Errata Sheet

This Errata Sheet contains corrections or changes made after the publication of this manual.

Product Family:	DL205	Date:	October 2018
Manual Number	D2-HP-M		
Revision and Date	1st Edition, Rev. A; May, 1998

Locking screw secures EEPROM in place. Locking screw replaces lever on models manufactured after October 2004.

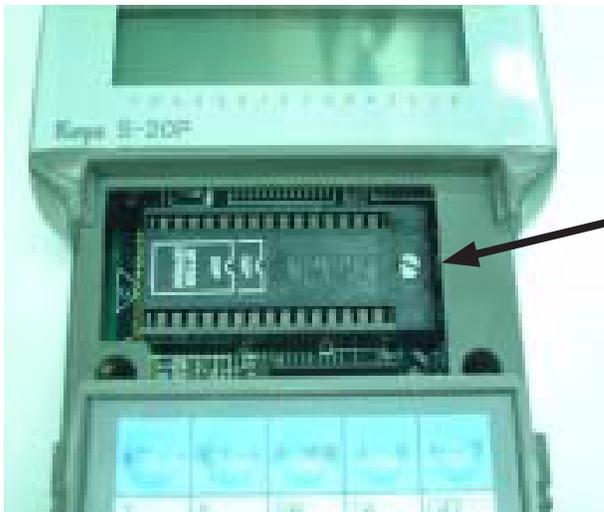
In late 2004, a design change occurred that changed how the EEPROM locks into place. The drawings and text on pages 1-6, 5-4 and 5-5 show the old design, whereby the EEPROM was held into place by a small lever. To replace the EEPROM, raise the lever to loosen the EEPROM. Once the replacement EEPROM is inserted in place, press the lever down to secure it.

On re-designed models, the lever arrangement was replaced by a locking screw, as shown in the photo below. Turn the screw clockwise to loosen and counterclockwise to tighten the EEPROM.

Handheld Programmer Layout

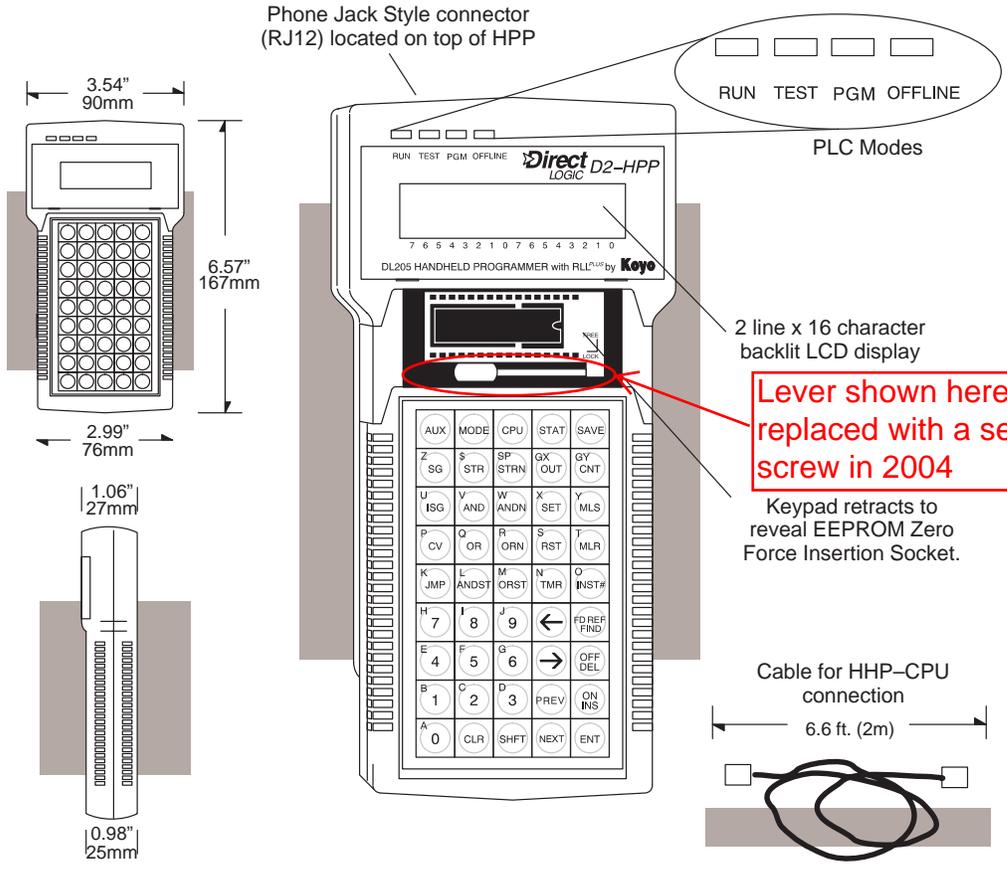
See Errata Sheet at the beginning of this file. In late 2004 the lever that secures the EEPROM was replaced by a securing screw.

Lever shown here was replaced with a securing screw in 2004

Correct cable is part number DV-1000CBL
